**REQUEST FOR DRAWING CHANGE APPROVAL**

## REMARKS

FIG.5

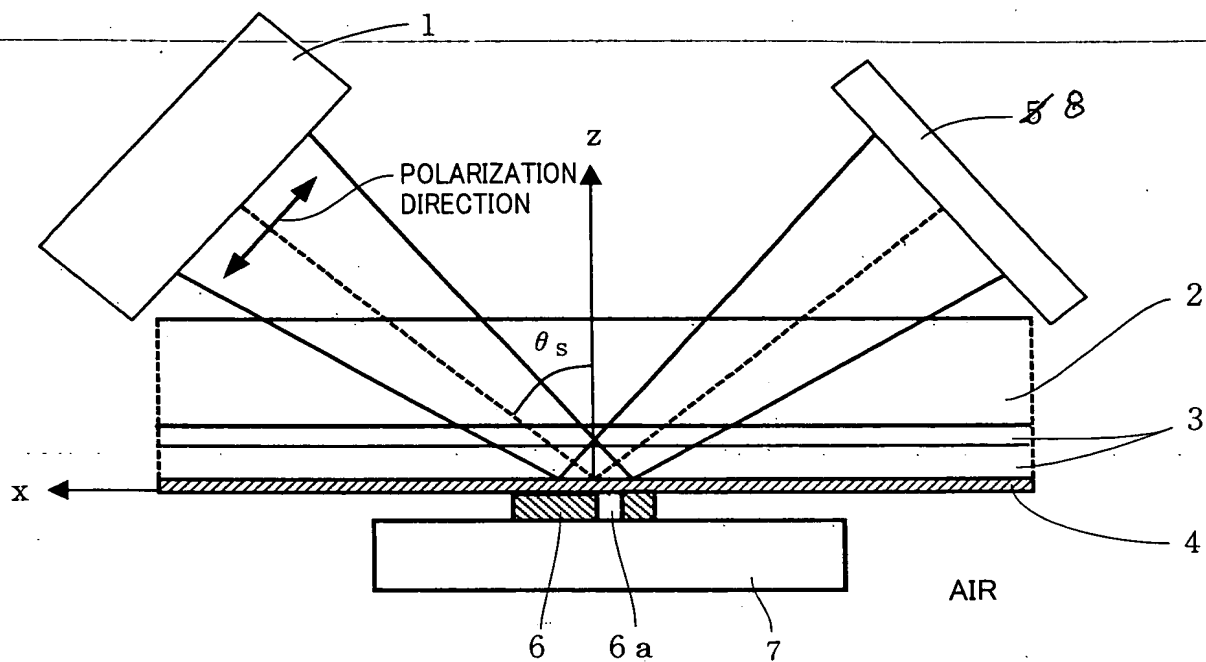
In the currently outstanding Official Action in the above-identified application, the Examiner has noted that the Applicants inadvertently utilized the reference numeral "5" to refer to two different elements. In order to correct that inadvertent error, Applicants propose that the reference numeral "5" that appears in Fig. 5 be changed so as to read -- 8 --. Approval of this drawing change as formally requested below and shown in red on the attached photocopy of Fig. 5 of the above-identified application is respectfully requested. Also, a corrected clean copy of the original page of drawing including Fig. 5 is enclosed herewith and designated "Replacement Sheet" in the upper margin as required by the Rules is enclosed herewith.

**In Fig. 5, please change the reference numeral "5" to -- 8 --.**

2. Objected to the formal drawings filed on 3 March 2005 on the basis that they fail to comply with 37 CFR §1.84(p)(4) because the reference character "5" has been used to designate both the Evanescent wave and the Photodetector as shown in Figures 1 and 3 on the one hand and 5 on the other hand, respectively. **Applicant has by the foregoing requested approval of a change to Fig. 5 of the drawings as originally filed that would delete the reference numeral "8" from Fig. 5 and substitute the reference numeral -- 5 -- therefor. A copy of the drawing sheet containing Fig. 5 showing the proposed change in red and a replacement sheet for the sheet of drawing containing Fig. 5 are both enclosed herewith as required by the Rules. Entry of the so proposed change to the drawings of this application and withdrawal of the currently outstanding drawing objection in view thereof is respectfully requested in response to this submission.**
